Access Compliance Report

Public Rights-of-Way

(Curb Ramps)

Intersection ID: 10040119	Main Street: TUFTON_BRAE_CT	Cross Street: N/A	Location: NE
ADA ID: 29FA2C922CFB	Ramp Type: Perp	Initial Pass/Fail: Pass	Overall Compliance: No
Severity Score: 0.25			
Codes/Mitigation Info/Possible Solution		Field Measurements/Component Compliance

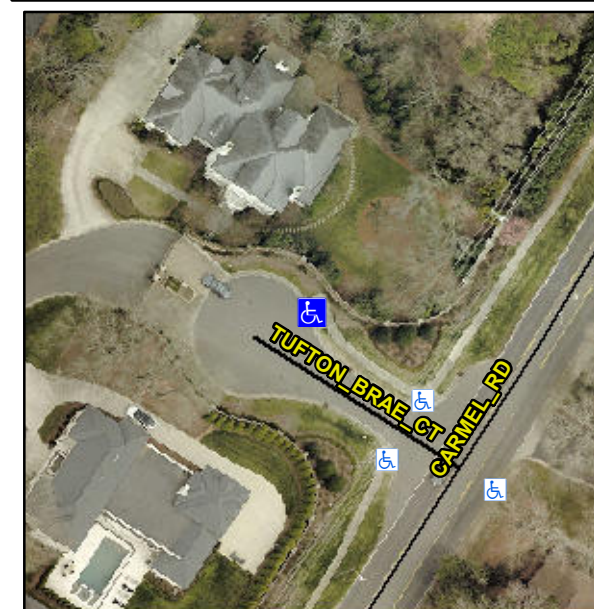
Not Found, R304.5.3, R304.2.2-Perp, R304.3.2-Para

Compliance	Description	Data	Compliance	Description	Data
N/A	Ramp Length (in)	48.0	Yes	Ramp Slope (%)	7.2
Yes	Ramp Width (in)	48.0	No	Ramp XSlope (%)	2.4
N/A	Flare Type LT	Sloped	N/A	Flare Type RT	N/A
N/A	Flare Slope LT (%)	5.9	Yes	Flare Slope RT (%)	3.9
N/A	Flare Traversable LT?	Yes	N/A	Flare Traversable RT?	Yes
Yes	Landing Length (in)	59.0	Yes	DWS Provided?	Yes
Yes	Landing Width (in)	48.0	Yes	DWS Contrast?	Yes
No	Landing Slope (%)	2.5	Yes	DWS Length (in)	24.0
Yes	Landing X Slope (%)	2.1	Yes	DWS Full Width?	Yes
N/A	Landing Curb? (Y/N)	No	Yes	DWS Offset (in)	0.0
N/A	Shared Landing?	No			
Yes	Gutter Ponding?	No	Yes	Gutter Slope (%)	0.9
Yes	Gutter Lip Ht (in)	0.0	Yes	Gutter X Slope (%)	1.8
N/A	Painted X Walk1?	No	N/A	Painted X Walk2?	N/A
	X Walk 1 Direction	To SW		X Walk 2 Direction	N/A
N/A	X Walk 1 Width (in)	N/A	N/A	X Walk 2 Width (in)	N/A
	X Walk 1 Slope (%)	3.7		X Walk 2 Slope (%)	N/A
	X Walk 1 X Slope (%)	2.2		X Walk 2 X Slope (%)	N/A

Remove & Replace Entire Ramp.
